Second Revision No. 7898-NFPA 70-2024 [Detail]

Committee: NEC-P12

Figure Informational Note 620.62 Selective Coordination for Overcurrent Protective Devices Supplying More Than One Elevator.

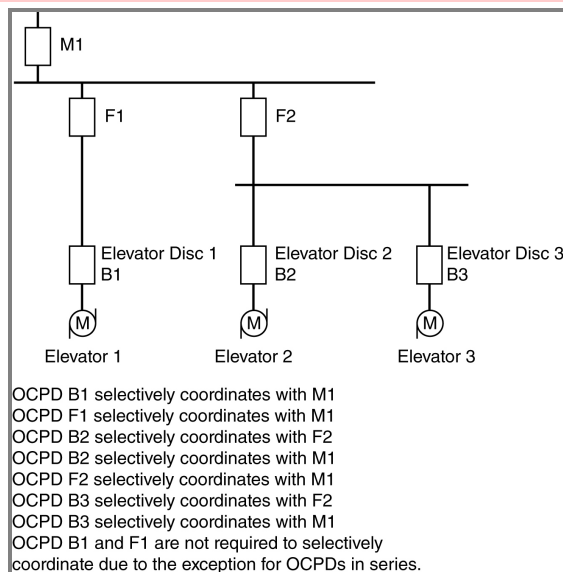
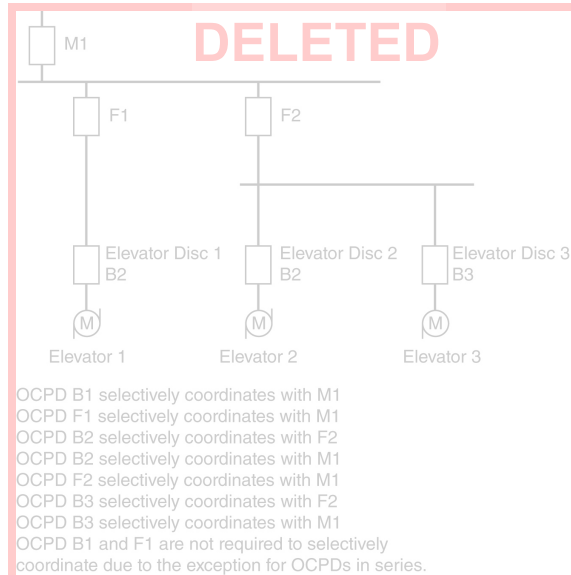
<u>File Name</u>	<u>Description</u>	<u>Approved</u>
Corrected_Figure_for_620.62_C_.docx	Figure showing where to correct the existing B2 under Elevator Disc 1 to B1 for Figure Informational Note 620.62 Selective Coordination for Overcurrent Protective Devices Supplying More Than One Elevator.

Committee Statement: The change to the overcurrent device terminology is for consistency throughout the code. The revision to the figure corrects an error in the figure as the B2 under Elevator Disc 1 in the figure should be B1.

If modifications, additions, or deletions to the elevator system(s) occur, selective coordination of the elevator system(s) OCPDs with all supply-side and load-side OCPDs shall be re-evaluated.

Exception: Selective coordination shall not be required between two ~~overcurrent~~ devices OCPDs located in series if no loads are connected in parallel with the downstream device.

Informational Note: See Figure Informational Note 620.62 for an example of how OCPDs supplying elevators selectively coordinate with all supply-side OCPDs.
